**SOS CHILDREN'S VILLAGE
ADMINISTRATIVE BUILDING ADDITION**

January 19, 2021

DRC LANDSCAPE COMMENTS

Proposed Planting Addition
Butterfly Planting Palette

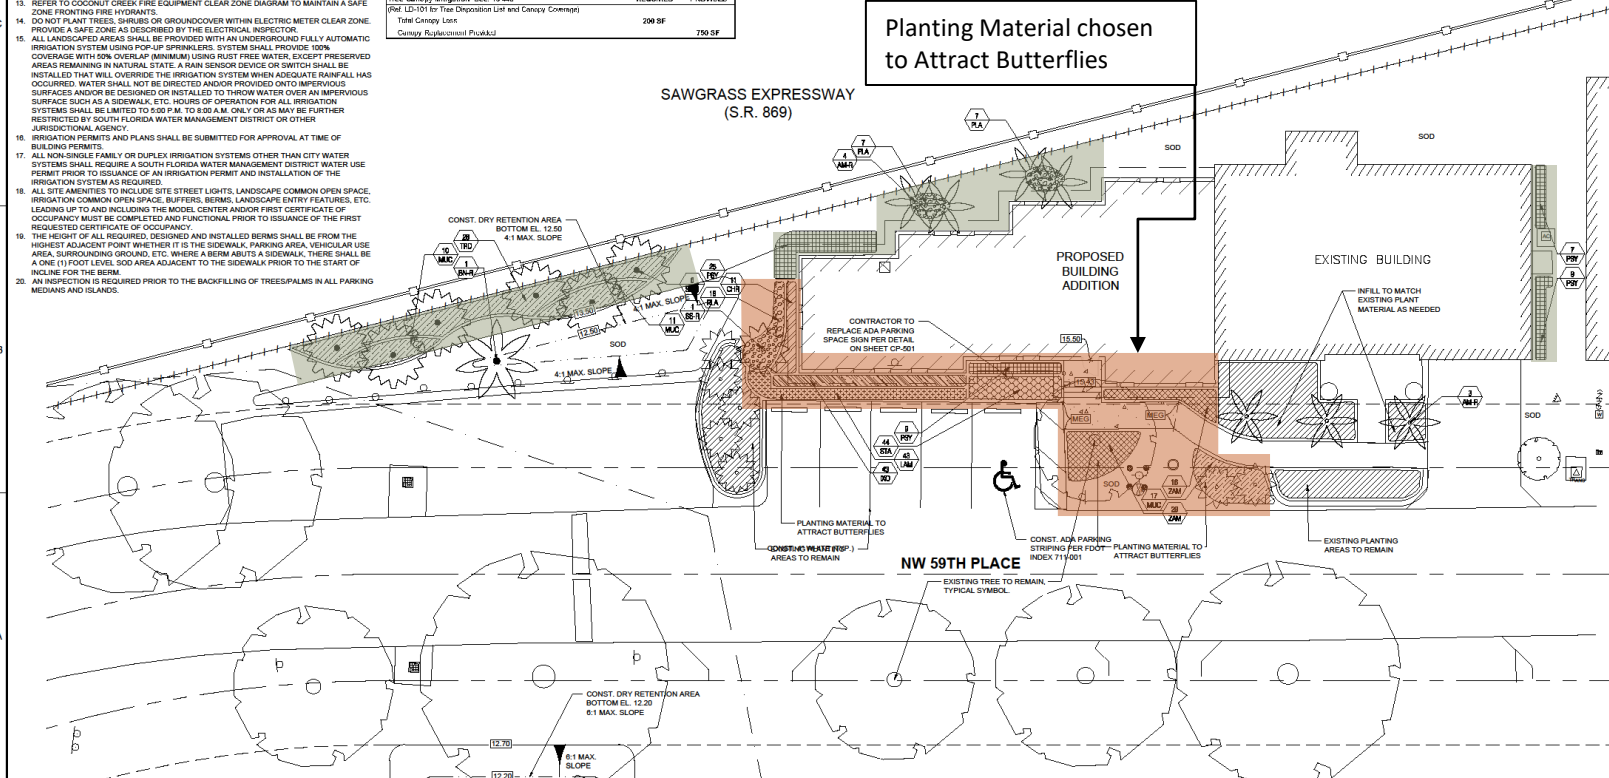
4. IDENTIFY PLANT MATERIAL IN AREA NOTED AS “BUTTERFLY” AREA, WHICH IS THE “CONSPICUOUS DISPLAY OF GREEN” FOR THE SITE AS NOTED IN THE ZONING RESPONSES.

RESPONSE: BUTTERFLY GARDEN PLANT SPECIES WILL BE ELABORATED ON THE PLAN SHEET LP-101

ILLUSTRATIVE PLAN

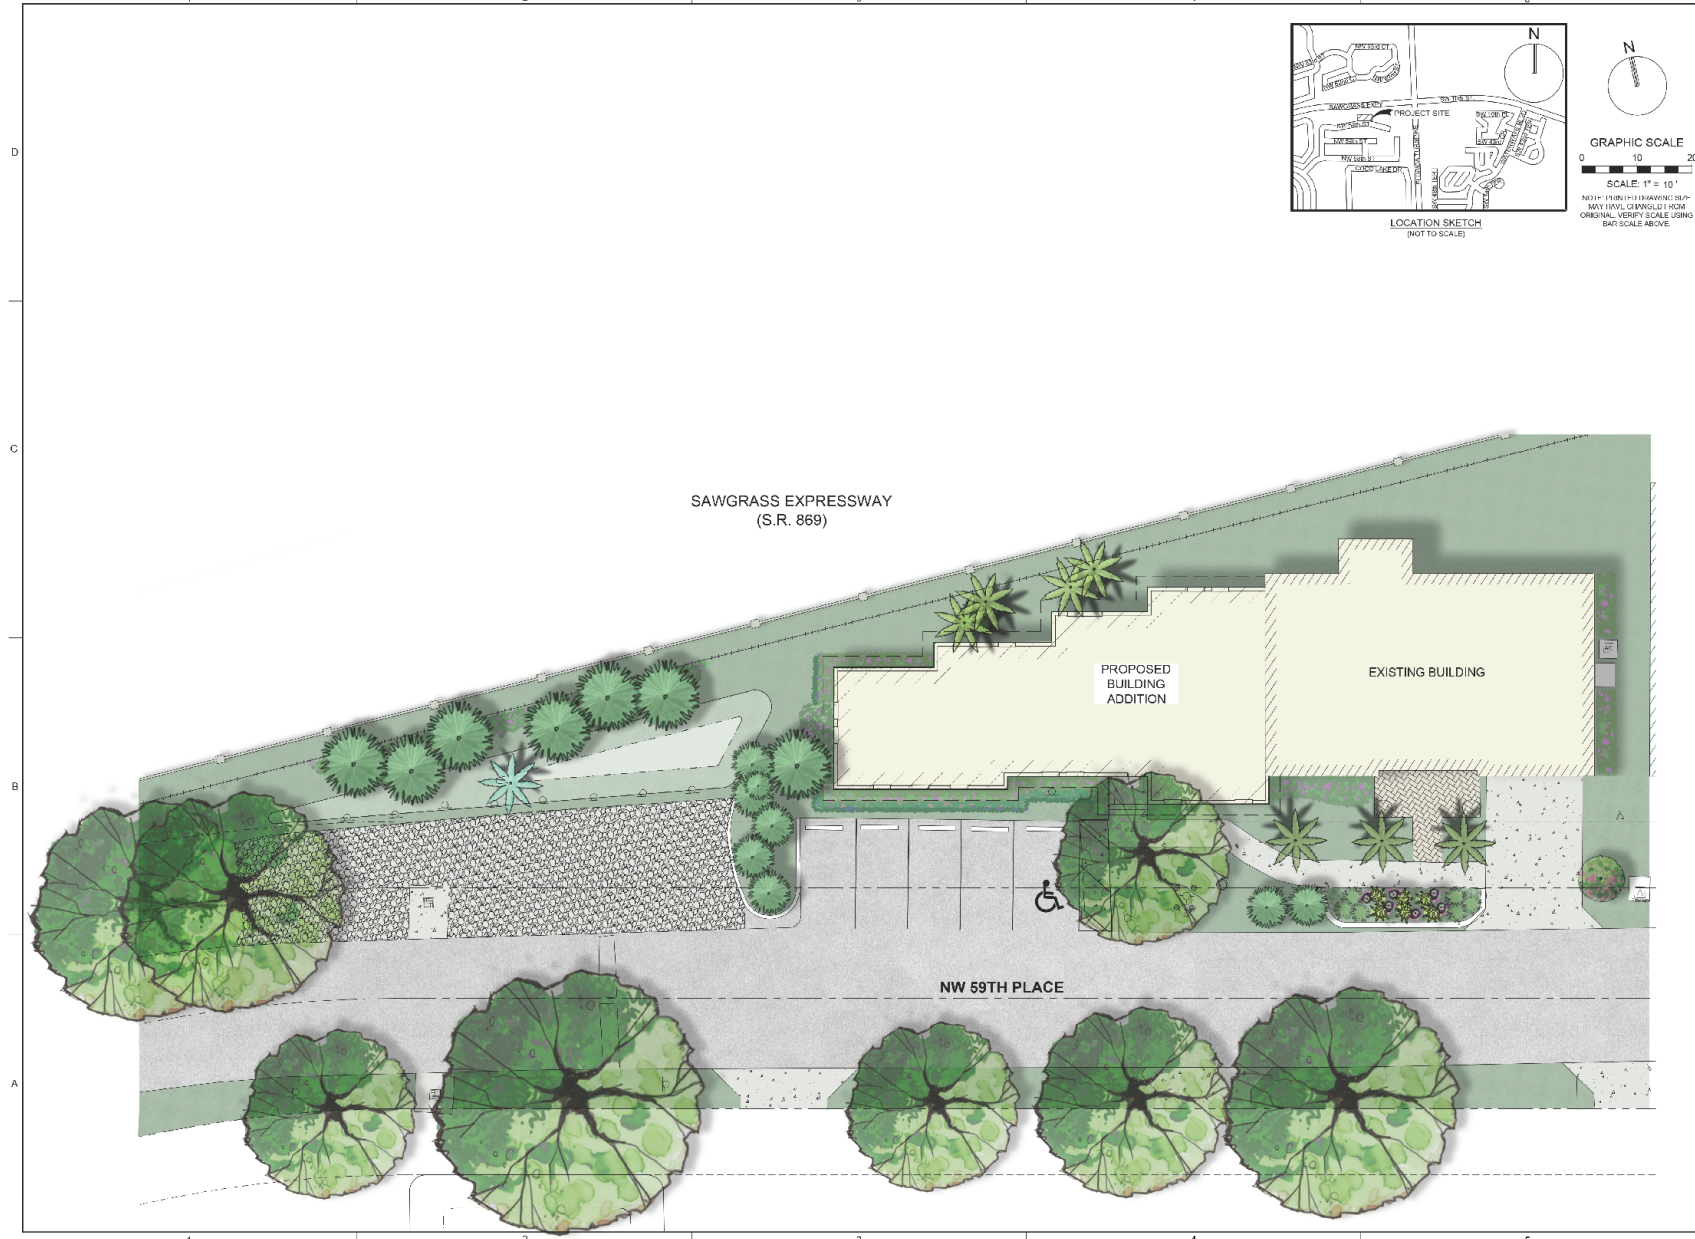
1. PLANT DATA TABLE: CHRISTMAS PALM, ARIKURY PALM, AND IXORA ARE NOTED AS NATIVES AND THEY ARE NOT. REVISE THE TABLE ACCORDINGLY.

2. EXTEND THE PROPOSED WILD COFFEE HEDGE TO SURROUND THE AC UNIT ON THREE SIDES AS REQUIRED BY CODE.

3. THE PROPOSED LOCATION FOR THE THREE RELOCATED ADONIDIAS ADJACENT TO THE EXISTING BUILDING ARE WITHIN A UTILITY EASEMENT. RELOCATE PALMS OUTSIDE OF THIS EASEMENT. (EXISTING TREES MAY REMAIN IN THE EASEMENT UNLESS OTHERWISE NOTED BY ENGINEERING.)

RESPONSE: PLANTING DATA REVISED ACCORDINGLY

RESPONSE: HEDGE WILL BE EXTENDED TO THREE SIDES OF AC UNIT

RESPONSE: THE THREE ADONIDIAS WILL BE LOCATED OUT OF THE EXISTING EASEMENT IN COORDINATION WITH THE CITY
